June 11, 1996
LD-96-021

Docket 52-002

Subject: Changes to the System 80+™ Standard Plant Design

Potential System 80+ Design Changes

Figure 3.5.4-1
Allowed IRWST Temperature vs. Containment Atmosphere Temperature

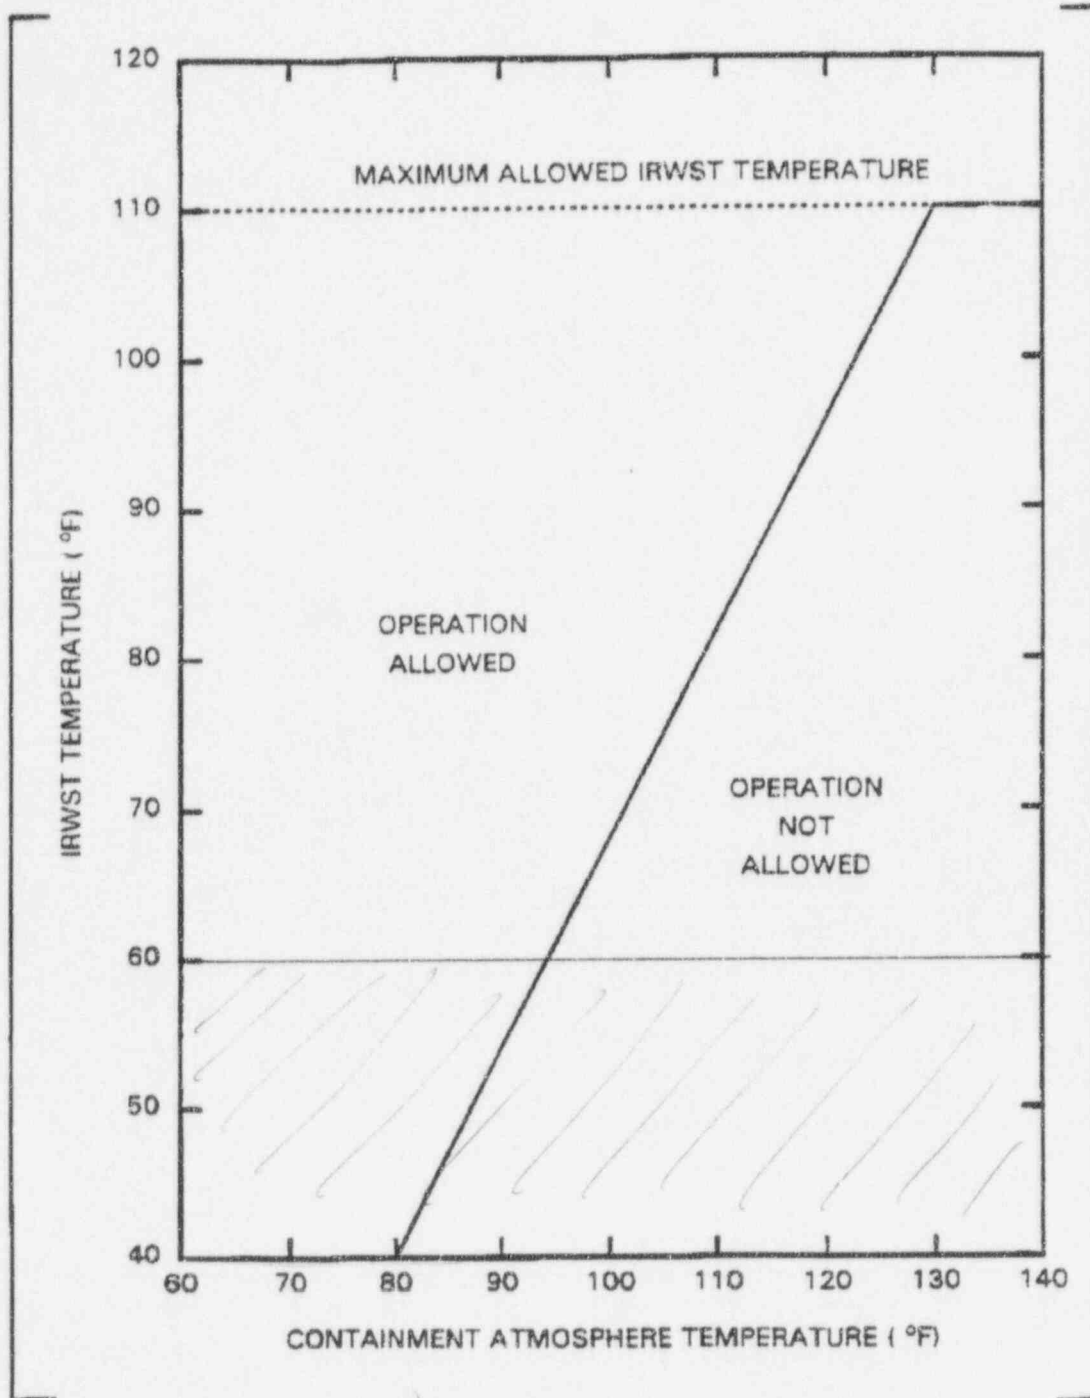
4	Ch 16, Fig 3.4.5-1	Evaluate need to revise Tech Spec on IRWST temperature. Fig 3.5.4-1 indicates IRWST limit is 40F; analysis limit is 60F. Confirm whether Tech Spec Figure in Ch 16 should be updated to 60F.
5	Ch 4; Figs in Ch 3, 5 ITAAC	Twelve (12) CEA locations in core center region should be added and designated as "spares." These would allow additional maneuvering capability. Requires correction of CEA locations shown in ITAAC Fig 2.2.1-3, ADM Fig 4.2-11, ADM Fig 4.3-46, ADM Fig 4.3-47. Also modify Section 4.2.2.4 to accommodate extra CEAs.
6	Ch 5	Revise mid-loop level monitor to accommodate ex-vessel device.
7	Ch 6, Ch 3.6	Reduce SDS line/valve size from 6" to 4" per YGN qualification data. Revise Figure 5.1.2-3.
8	Ch 3	Modify Piping Evaluation Diagrams to be consistent with NRC-approved criteria for AP600. Change load combination factor from 1.4 to 1.0.
9	Pg 9.3-29	Section 9.3.4.2.1 states interlock provided so only one chg pump can be operated during all modes of plant operation. [Ch 15 limits chg flow to 150 gpm for boron dilution; also Tier 1 commitment.] This means that one charging pump must be stopped before the standby pump can be started. Momentary loss of RCP seal injection may occur.

ITEM 4

DELETE
FROM
FIGURE

Control Element Assembly Locations

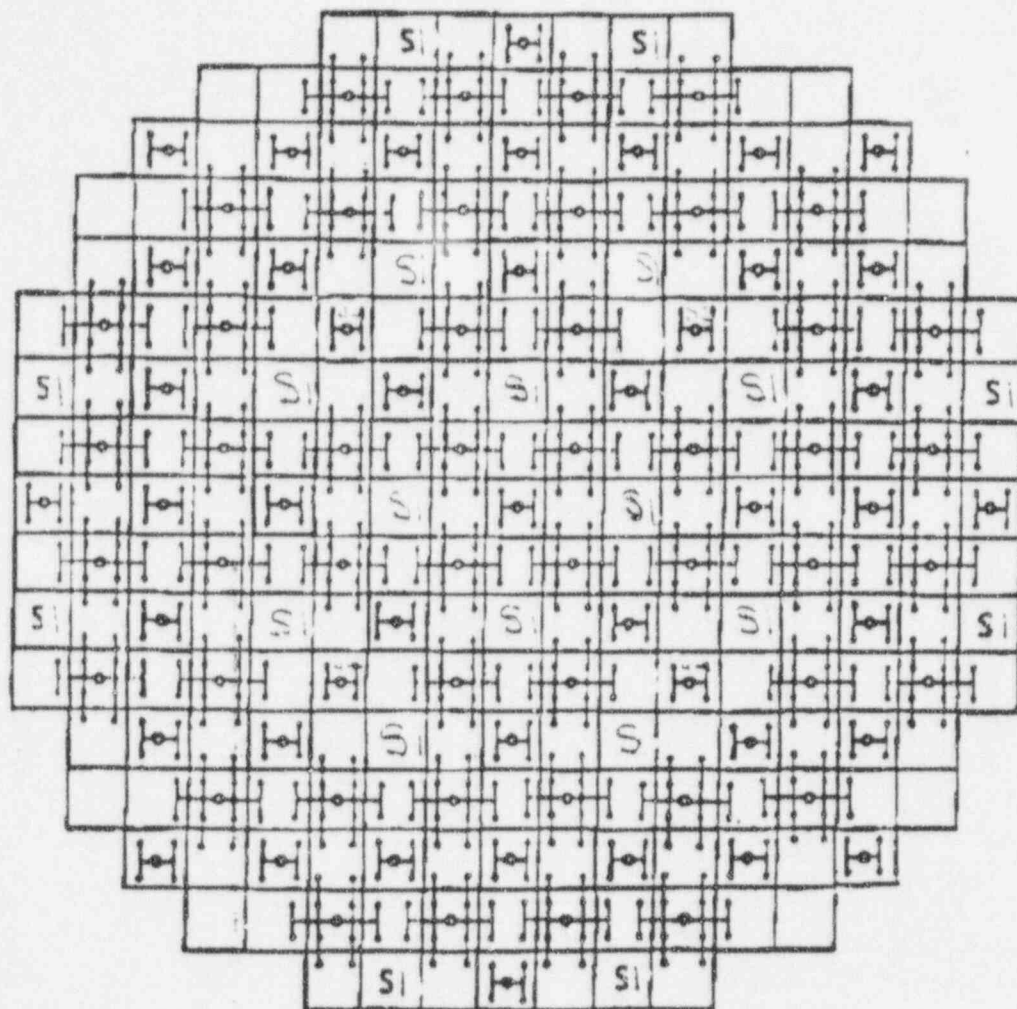
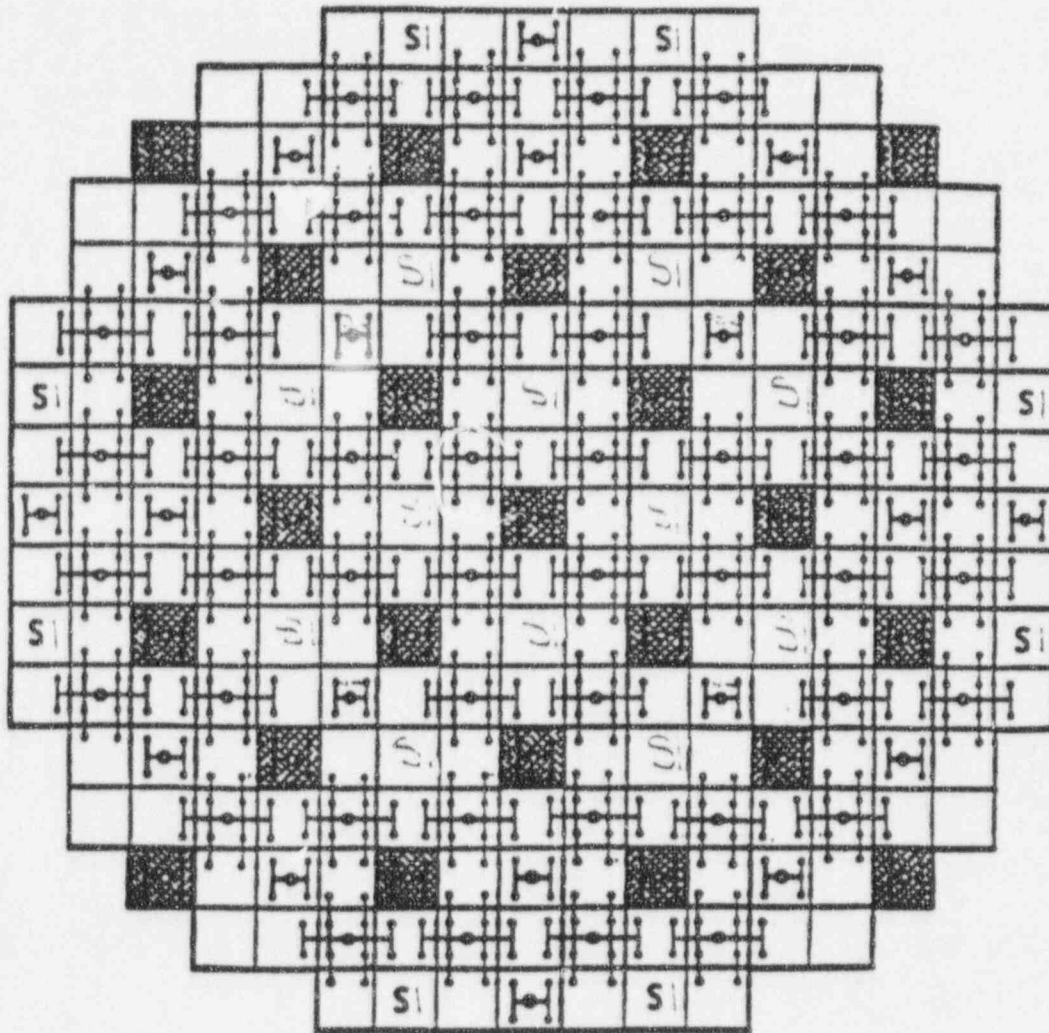
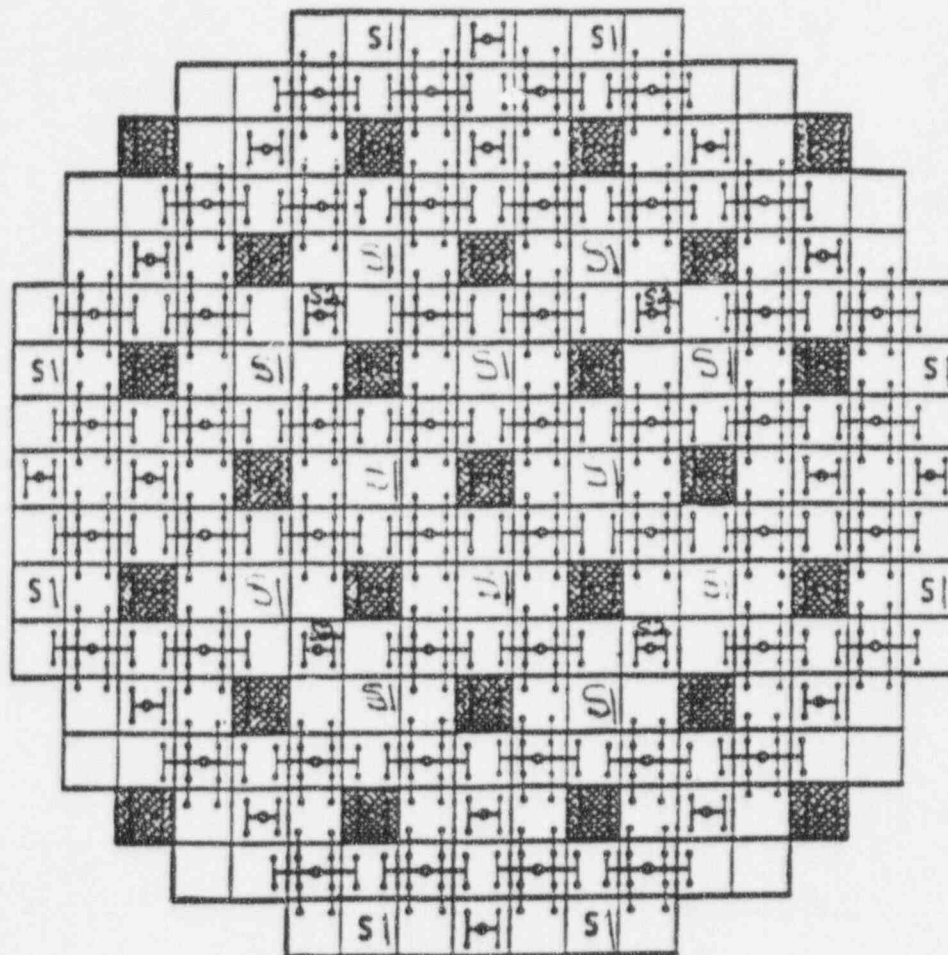
Affected DCD Sections: CDM: Yes, Figure 2.2.1.3; eliminate the maximum number of CEDMs in Section 2.2.2
ADM: Yes, Figure 4.2.11, Figure 4.3-46, Figure 4.3-47, Text in Section 4.2.2.4

The objective of the change is twofold: (1) allow for the possibility of having 4 element CEAs at twelve specific core locations; and (2) allow for the possibility of replacing 4-element CEAs with 12-element CEAs at for specific core locations. Part (1) of the change is accomplished by identifying twelve core locations (in addition to the eight core locations previously identified) for spare locations which may contain 12 element CEAs instead of 4 element CEAs. Not all of the locations identified for spare 4 element CEAs would necessarily contain CEAs. The minimum number of CEAs would remain at 93.

The proposed change would allow flexibility in choosing locations for additional CEAs and/or CEA elements. The addition of CEAs in the central core region would permit enhanced maneuvering capability. The addition of CEAs or CEA elements could also improve shutdown margin. All locations identified for additional CEAs satisfy the minimum reactor vessel head ligament requirement.

The CDM (Figure 2.3.1-3) and the ADM (Figure 5.3-7) show a minimum of 103 CEDM and instrumentation nozzles, and a minimum of 2 HJTC probes. The proposed change would maintain these minimum values. Since specific CEDM locations are not shown in the ADM, the change permits the selection of 8 different core locations for spare CEAs from those currently shown, as well as the addition of spare CEAs at other core locations.

LOCATIONS WHICH MAY CONTAIN 12 ELEMENT CEAS
~~SPARE LOCATIONS FOR 2 CEA ELEMENTS~~

Figure 4.3-47

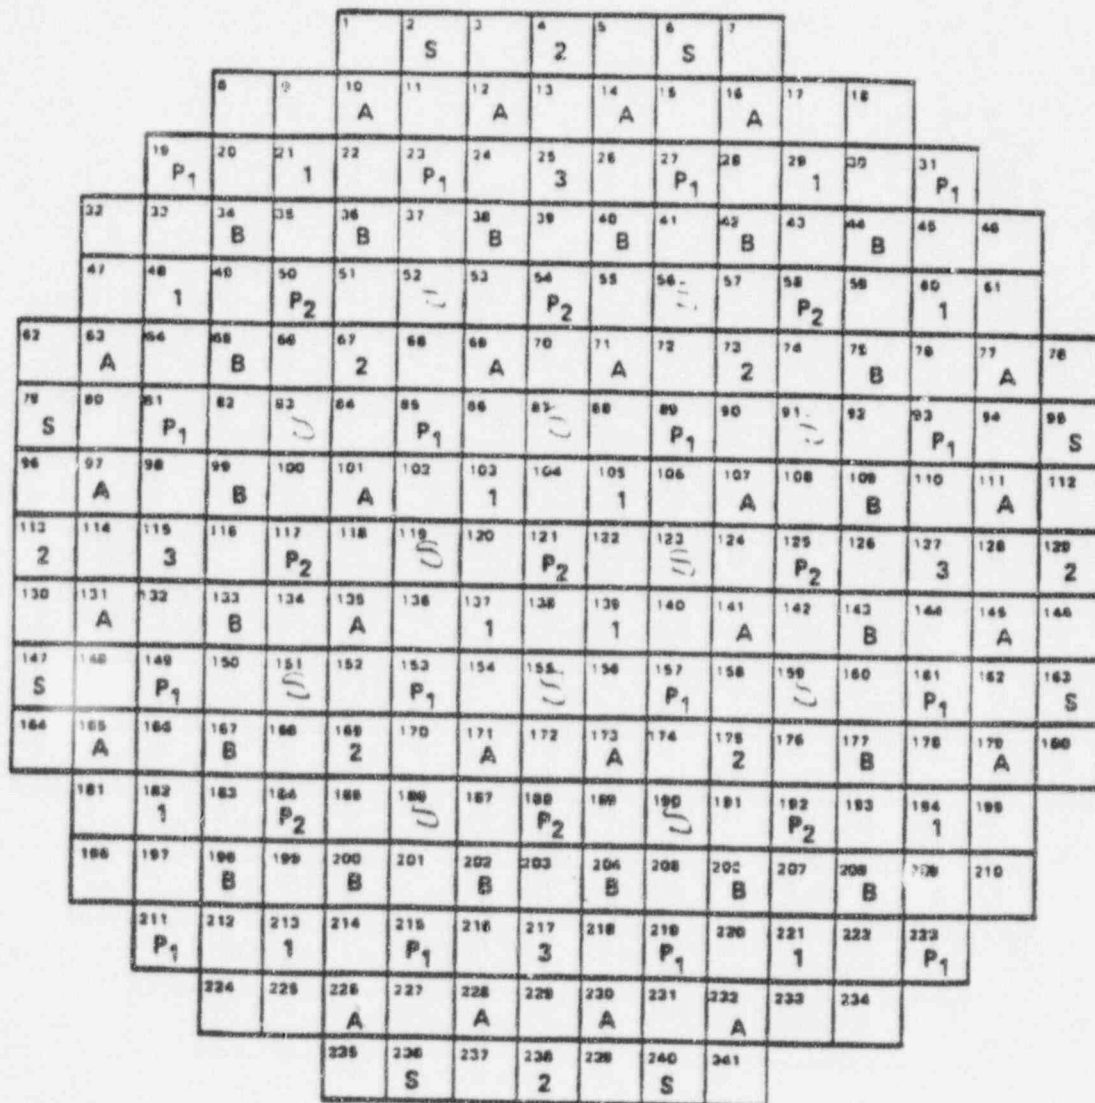
- P_2 - PART-STRENGTH GROUP 2 (LEAD)
 P_1 - PART-STRENGTH GROUP 1
 3 - FULL-STRENGTH REGULATING GROUP 3 (LEAD)
 2 - FULL-STRENGTH REGULATING GROUP 2
 1 - FULL-STRENGTH REGULATING GROUP 1
 B - SHUTDOWN GROUP B
 A - SHUTDOWN GROUP A
 S - SPARE CEA LOCATIONS

Figure 2.8-4

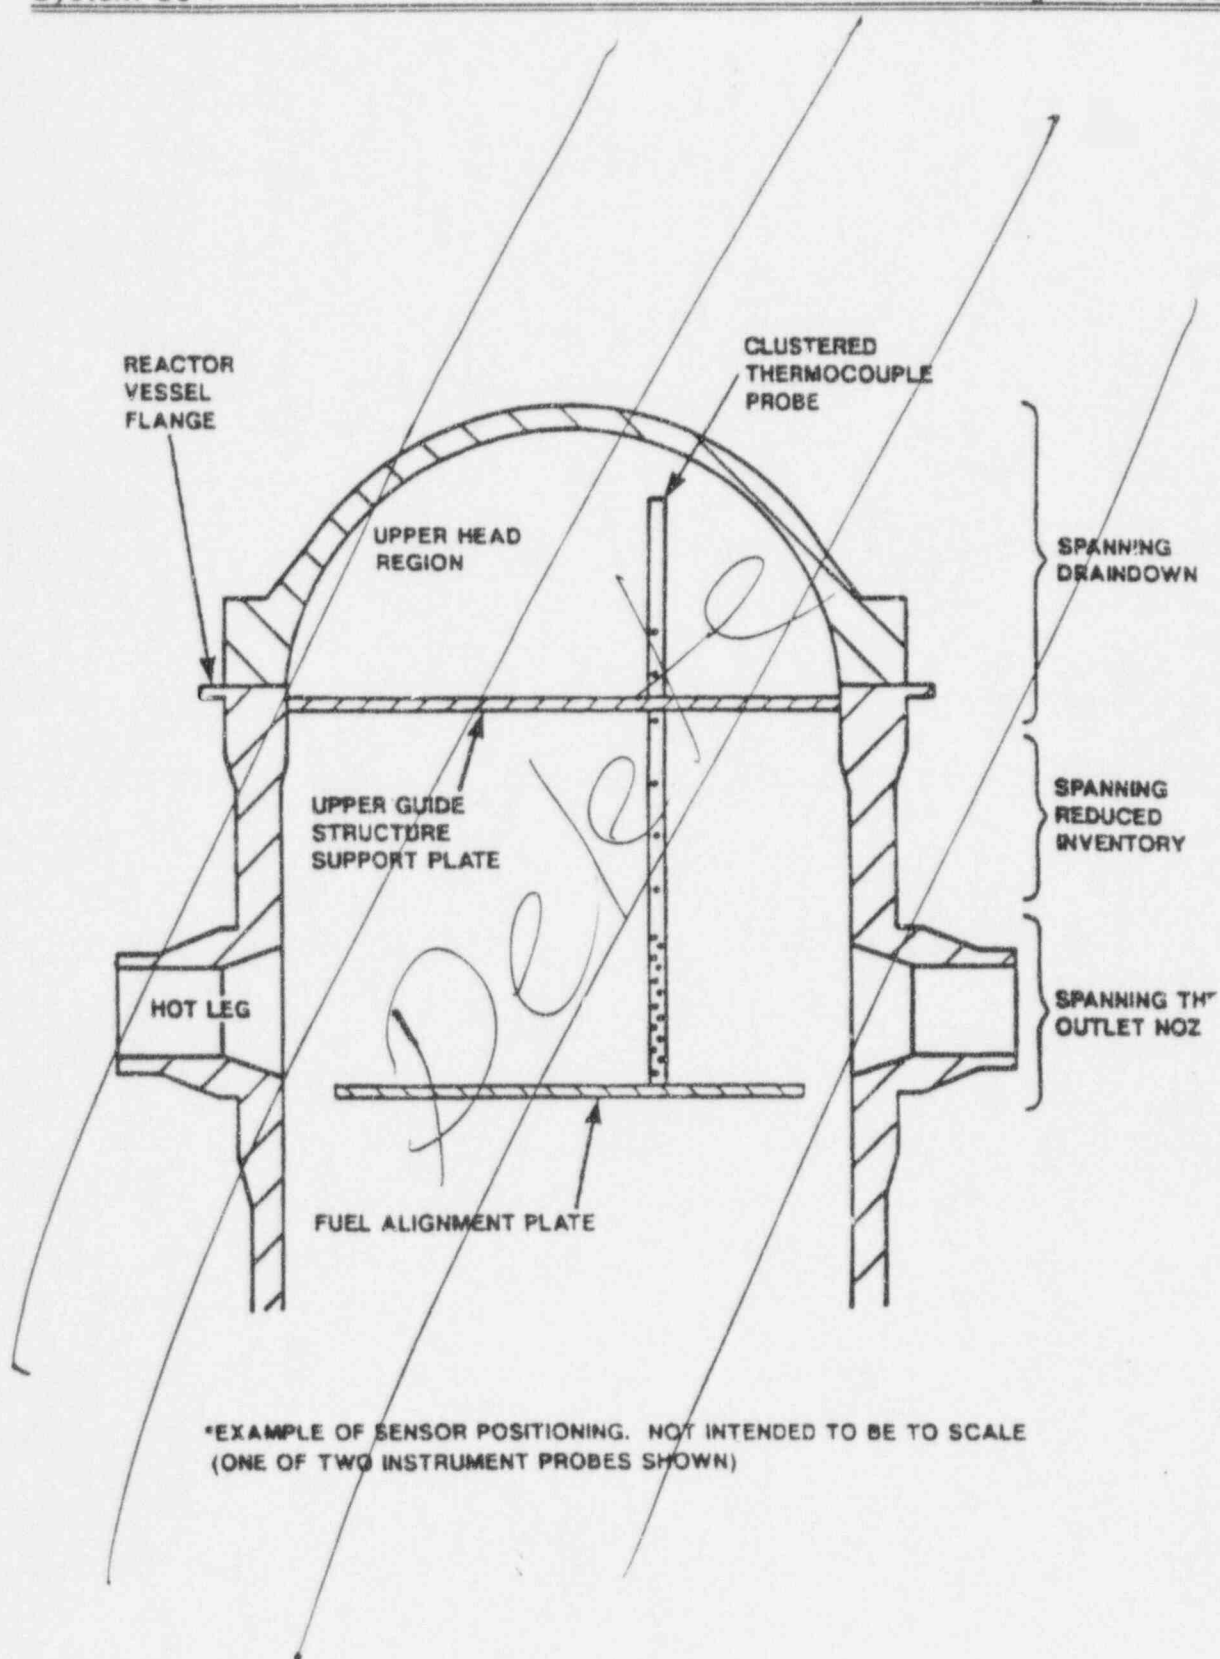
A detailed engineering evaluation was performed to confirm the feasibility of adding tanks connected directly across each of the RCS hot leg pipes to measure the hot leg water level during Mid-Loop operations using HJTC instruments. The current DCD Chapter 5 includes the RCS P&ID and the cross section of the Reactor Vessel. The Shutdown Risk evaluation reported in DCD Chapter 19.8A provides a figure (Figure 2.8-4) which indicates that two additional sets of HJTC's are inserted through the reactor vessel head to measure the hot leg water level. The DCD text indicates this level should be measured to an accuracy of plus or minus 1 inch. In Chapter 19 the tank across the hot leg will be shown for measuring the hot leg water level during mid-loop operations. The water level will be measured with heated junction thermocouples that operate in the same manner as the ICCMS HJTC located in the reactor vessel.

In addition to the dP-based instruments described above, two heated-junction thermocouple (HJTC) systems ~~will~~ ^{may} also be available for reactor vessel level measurement during Mode 5 reduced inventory operations. The first system displays the output from the two inadequate core cooling probes which are located inside the reactor vessel. The range of these probes extends from the reactor vessel head to the fuel alignment plate (See Figure 2.8-3). The measurement of RCS water level via these probes is limited only to those periods when the reactor vessel head is installed.

~~A second HJTC system provides narrow-range level indication for mid-loop operations via measurement of reactor vessel water level in the hot leg region.~~ ^{The} This system displays the output from two HJTC probes specifically designed with thermocouples clustered in the hot leg region (See Figure 2.8-4). The benefit of this design is that it permits very accurate measurement when the reactor vessel water level is in the hot legs. ^{is made}

Schematic of Connection of Equalization Line to RCS
(Not to scale and some details omitted)

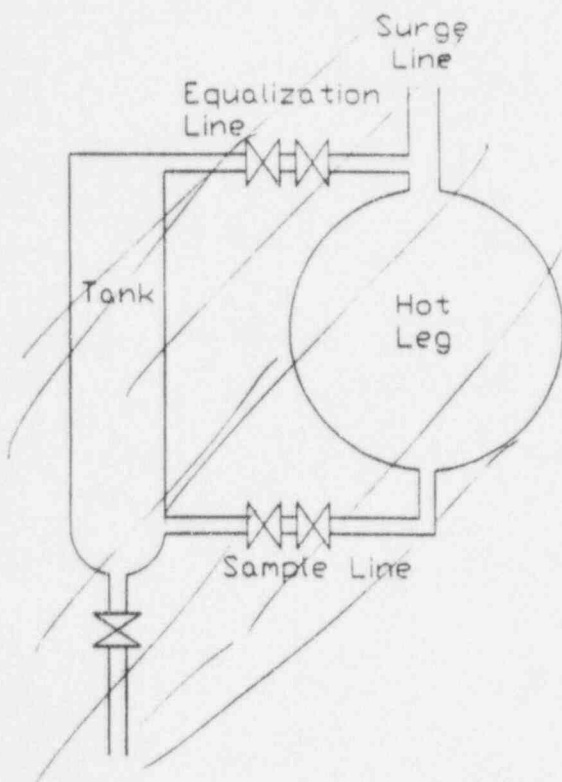
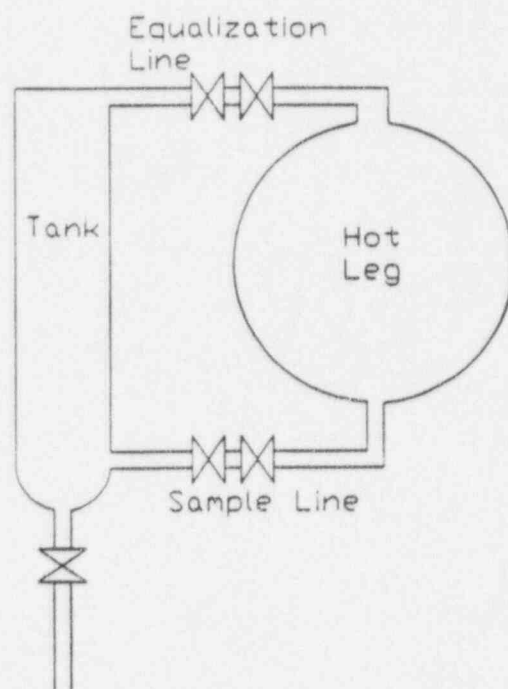
Add RCS Mid-loop Level Measurement Tank and Instrumentation Across the Hot Leg
